GRID CODE CONSULTATION DOCUMENT

Proposed changes to Connection Conditions CC.6.3.3 in respect of operation at frequencies below 49.5Hz.

Consultation Ref	E/03
Issue	1.0
Date of Issue	16 th June 2003
Responses required by	11th July 2003
Prepared by	National Grid

Figure 1

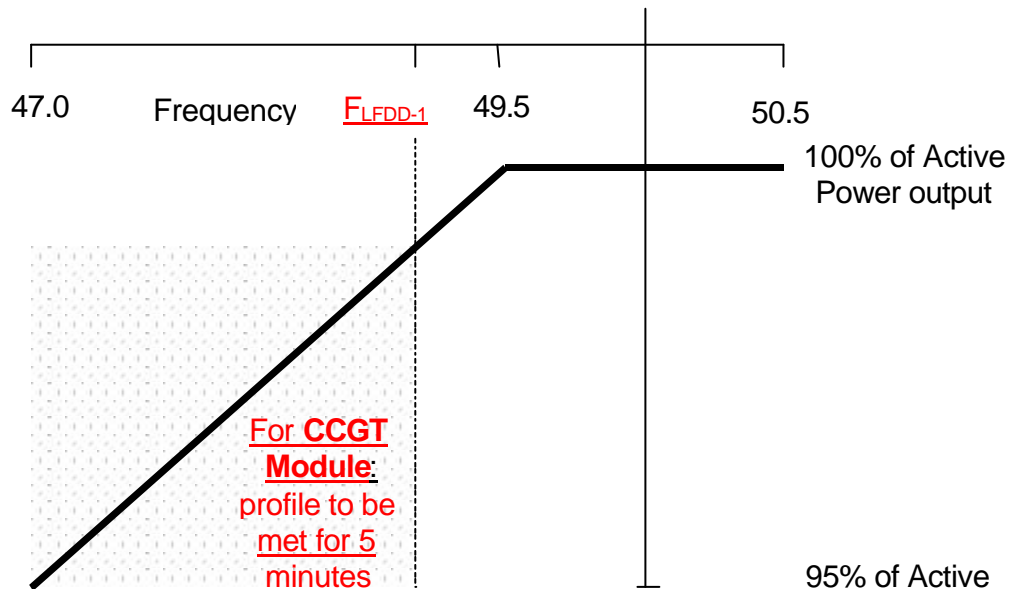
- 7.1 National Grid believes that the minimum system requirements can be met by adopting the following proposals.
- 7.2 It is proposed that the existing CC.6.3.3 requirements should be retained for frequencies down to the low frequency relay trip setting of the first stage of the automatic low frequency demand disconnection scheme of 48.8Hz.
- 7.3 For frequencies below the above setting where special action(s) are required to meet the existing requirements, it is proposed that the existing CC.6.3.3 requirements should be retained for a period of 5 minutes. Thereafter, a relaxation is proposed, and the special action(s) should be discontinued if there is a materially increased risk of the plant tripping. The need for special action(s) is linked to the inherent gas turbine active power output reduction caused by reduced shaft speed due to falling system frequency.

- 7.4 This relaxation may require control/time delay/mode switching functions to facilitate smooth transition between modes of operation. The implementation of such facilities must not introduce new unacceptable risks.
- 7.5 The proposed CC.6.3.3 text is given in Appendix 1. For all stakeholders (Generators, NGC, Distribution Network Operators and plant manufacturers) to obtain the benefits of this proposed relaxation, National Grid believes the proposals should be applied to all CCGT plant where there is a material increase in the risk of plant tripping during a prolonged period of operation below 48.8Hz.
- 7.6 For information the Working Group final report (paper GCRP 03/12) to the Grid Code Review Panel is available on the National Grid website:

- CC.6.3.3 Each **Generating Unit** and/or **CCGT Module** must be capable of
- (a) continuously maintaining constant **Active Power** output for **System Frequency** changes within the range 50.5 to 49.5 Hz; and
 - (b) maintaining its **Active Power** output at a level not lower than the figure determined by the linear relationship shown in Figure 1 for **System Frequency** changes within the range 49.5 to 47 Hz, such that if the **System Frequency** drops to 47 Hz the **Active Power** output does not decrease by more than 5%.

In the case of a CCGT Module, the above requirement shall be retained down to the Low Frequency Relay trip setting of 48.8 Hz, or such other setting notified by NGC to the User, which will reflect the first stage of the Automatic Low Frequency Demand Disconnection scheme notified to Network Operators under OC6.6.2. For System Frequency below that setting, the existing requirement shall be retained for a period of 5 minutes while it remains below that setting, and special action(s) that may be required to meet this requirement shall be kept in service during this period. At the end of that 5 minutes period, if System Frequency remains below that setting, the special action(s) must be discontinued if there is a materially increased risk of the Gas Turbine tripping. The need for special action(s) is linked to the inherent Gas Turbine Active Power output reduction caused by reduced shaft speed due to falling System Frequency.

Note: Frequency F_{LFDD-1} is the relay trip setting of the first stage of the Automatic Low Frequency Demand Disconnection Scheme
